ISSUE: Permit to Demolish/Capsulate (partial) and Certificate of Appropriateness for an addition and alterations

LOCATION: Old and Historic Alexandria District
508 North Washington Street

STAFF RECOMMENDATION

Staff recommends approval of the Permit to Demolish/Capsulate (partial) and Certificate of Appropriateness for an addition and free standing structure as submitted.

Figure 5: Proposed east elevation

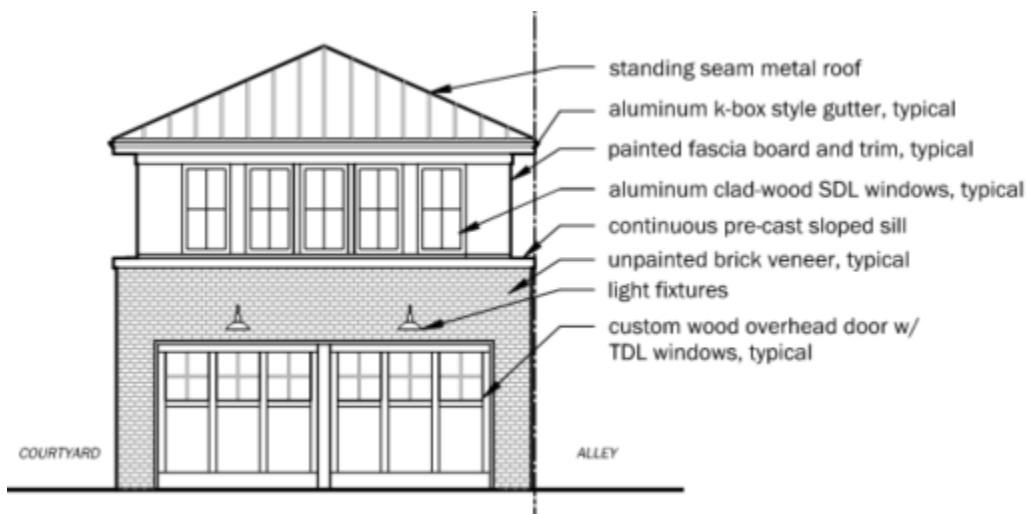
The proposed Accessory Dwelling Unit (ADU) at the rear of the property will be a simple 20 foot square, two story structure with ground floor parking and a residential unit above. The building will feature overhead doors at the north and west elevations on the ground floor for vehicular access and an exterior metal stair on the east elevation providing access to the upper level. Pedestrian access to the ground floor will be through a door on the east elevation centered on the second floor door above. The lower level of the structure will be clad in unpainted brick capped with a precast sill. The upper level will be painted wood that is set back from the brick below. Side by side, two over two windows will be located on the upper level beneath a standing seam metal pyramidal roof. See figures 5-8 below for the proposed design.

As with the design of the proposed addition, the design for the ADU takes cues from existing nearby historic structures. The square shape and higher pitch pyramidal roof are reminiscent of the existing carriage house at 708 Pendleton Street, which is in the same alley as the proposed structure. The ganged windows and recessed upper levels give the impression of a turret on top of the heavier brick base. The use of unpainted masonry and painted wood trim is reminiscent of the existing historic building while being clearly modern and secondary to the main structure.
